Staff Report to the County Commission

Application Request: Consideration and action on a request to amend the conditional use permit for the Terakee

Village PRUD.

Applicant: Brad Blanch File Number: CUP 2017-02

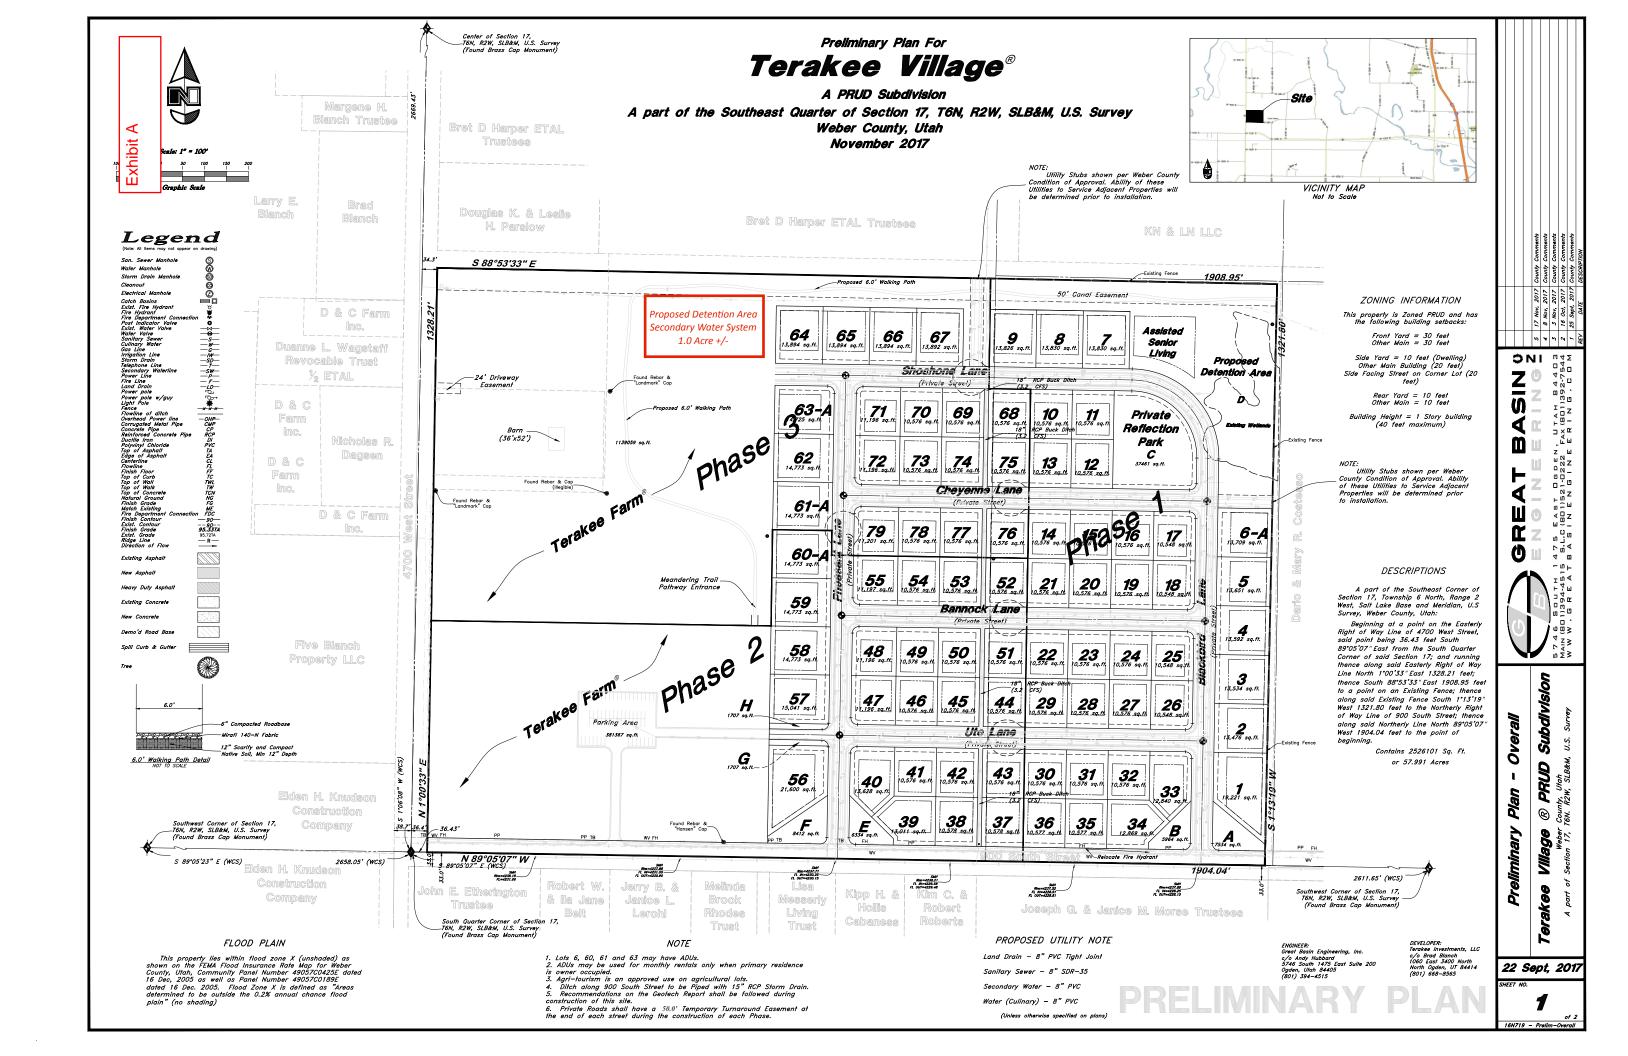
The purpose of this PRUD amendment is to amend the open space plan, to include within the open space a detention area as part of the proposed secondary water system. The applicant has provided a new site plan (Exhibit A) showing the proposed location of the detention area within the open space. The applicant, during the conditional use permit approval process for the PRUD, was granted an overall bonus density of 32 percent for the entire project, creating an overall density of 84 dwelling units (79 residential units, one lot for an assisted living center, and four accessory dwelling units). The applicant was able to receive the 32 percent bonus density, in part because of the 32 acres preserved as open space.

<u>Open Space:</u> The applicant is proposing to add a detention area for a secondary water system within the area previously approved as agricultural open space parcel to be used for agritourism. The detention pond is being proposed because the developer is required to either connect to Hooper Irrigation's secondary line, or to provide an onsite secondary water system to receive subdivision approvals. During final subdivision approval from the planning commission for Terakee Village Phase 1, the developer indicated that he planned to connect to Hooper Irrigation. The developer is now proposing to create a new secondary water district to maintain the proposed onsite system.

As this amendment was brought to the Western Weber Planning Commission on August 13, 2019, the Planning staff recommended that the Planning Commission approve this request and consider the secondary water pond to be 'open space' thereby keeping the same amount of density allowed under the original approval. The staff report to the Planning Commission is included as exhibit C. The Planning Commission chose to approve of the amendment to the conditional use permit, but did not consider the secondary water pond to be open space.

<u>Staff Recommendation Option 1:</u> If the County Commission chooses to follow the recommendation and findings of the Planning Commission, the development would be required to lose a certain amount of density, as the open space is reduced to below 32 percent. If the Commission chooses to follow the Planning Commission's recommendation staff recommends that the development lose one lot, to make up for the loss of open space.

<u>Staff Recommendation Option 2</u>: If the County Commission approves of the amendment and considers a secondary water pond to be 'open space', then no reduction in density is necessary and staff recommends that the decision be based on the finding that the proposed secondary water pond is considered to be open space.

On August 13, 2019 the Western Weber Planning Commission approved the request to amend the conditional use permit to show the secondary water pond as part of the development. The recommendation for approval is based on the review agency requirements and based on the following conditions:

- 1. All conditions from the original conditional use permit approval are still applicable.
- 2. The applicant must obtain approval from the state for the new secondary water system prior to subdivision approval from the County Commission.
- 3. That the front yard setbacks be changed from 30 feet to 20 feet (at the request of the applicant) with the condition that no front yard fencing be allowed.
- 4. The applicant provide a landscaping plan for the secondary water pond

1. That the new secondary water pond does decrease the amount of open space designated in the original site plan as it is not considered open space.
